IDAPA 39 – IDAHO TRANSPORTATION DEPARTMENT

39.03.41 – Rules Governing Traffic Control Devices

Figure 2B-33. Slow And Move Over For Stopped Vehicles With Flashing Lights Sign

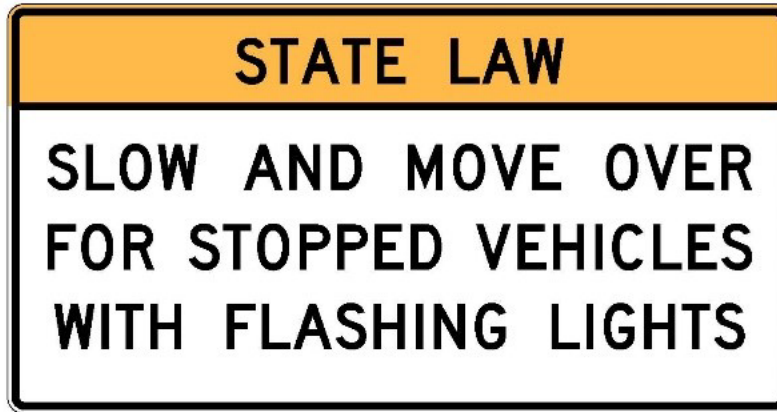
08. Figure 2B-33. Slow and Move Over for Stopped Vehicles with Flashing Lights Sign. On page 102, add the following figure:

07. Section 2B.69, SLOW AND MOVE OVER FOR STOPPED VEHICLES WITH FLASHING LIGHTS (R16-101) sign. On page 102, add the following section:

Support:
01 State law requires drivers approaching stationary police, emergency, tow truck, or highway incident response vehicles to slow on two-lane highways and to slow and move over on multi-lane highways.

Option:
02 The SLOW AND MOVE OVER FOR STOPPED VEHICLES WITH FLASHING LIGHTS (R16-101) sign (see Figure 2B-33) may be used to inform road users of the state law on multi-lane highways.

Standard:
03 If used, the SLOW AND MOVE OVER FOR STOPPED VEHICLES WITH FLASHING LIGHTS sign shall only be used on highways with two or more lanes in each direction.

Option:
04 The legend STATE LAW may be displayed at the top of the SLOW AND MOVE OVER FOR STOPPED VEHICLES WITH FLASHING LIGHTS sign.

Standard:
05 If used, the legend STATE LAW shall be black with a black border on a yellow background.

Figure 2B-34. Chains Required On Non-Exempt Commercial Vehicles Sign

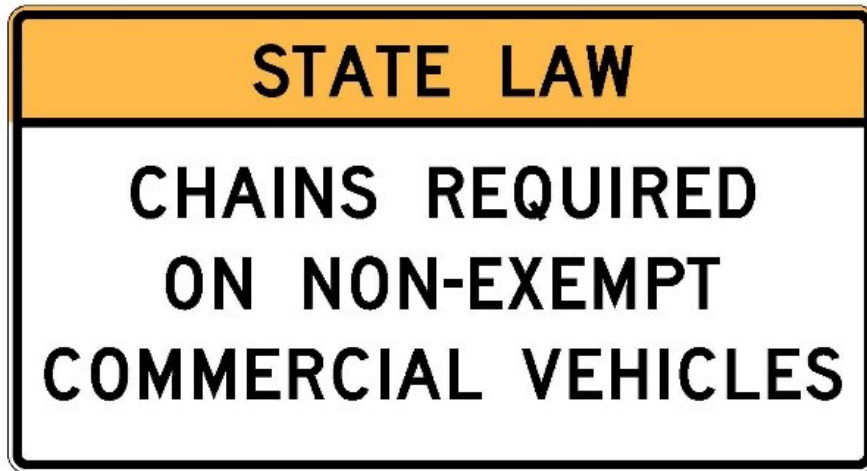
10. Figure 2B-34. Chains Required on Non-Exempt Commercial Vehicles Sign. On page 102, add the following figure:

09. Section 2B.70, CHAINS REQUIRED ON NON-EXEMPT COMMERCIAL VEHICLES (R16-201) sign. On page 102, add the following section:

<p>Standard:</p> <p>01 CHAINS REQUIRED ON NON-EXEMPT COMMERCIAL VEHICLES (R16-201) signs (see Figure 2B-34) shall be installed when mountain passes are determined to be unsafe by the Idaho Transportation Department. If used, two or more CHAINS REQUIRED ON NON-EXEMPT COMMERCIAL VEHICLES signs shall be installed in advance of an area that has been provided for drivers to pull off of the highway to install chains on their tires (see Section 2I.07).</p> <p>Support:</p> <p>02 Commercial vehicles required to use chains include:</p> <ul style="list-style-type: none">• Vehicles with a combined weight in excess of 26,000 pounds including a trailer with a rating of more than 10,000 pounds• Vehicles with weight in excess of 26,000 pounds <p>03 Commercial vehicles exempt from chain requirements include:</p> <ul style="list-style-type: none">• Idaho Transportation Department vehicles used in the maintenance of the highway• School busses or other vehicles used to transport school children and teachers• Vehicles used by farmers to transport agricultural products, supplies, or farm equipment• Mail carrier vehicles• Motor carriers transporting forest products or chips• Motor carriers transporting mining products including sand, gravel, and aggregates, but not petroleum products• Tow trucks <p>Standard:</p> <p>04 The CHAINS REQUIRED ON NON-EXEMPT COMMERCIAL VEHICLES signs shall be removed or covered when the condition no longer applies.</p> <p>05 The CHAINS REQUIRED ON NON-EXEMPT COMMERCIAL VEHICLES sign shall have a black legend and border on a white background.</p>

Option:
06 The legend STATE LAW may be displayed at the top of the CHAINS REQUIRED ON NON-EXEMPT COMMERCIAL VEHICLES sign.

Standard:
07 If used, the legend STATE LAW shall be black with a black border on a yellow background.
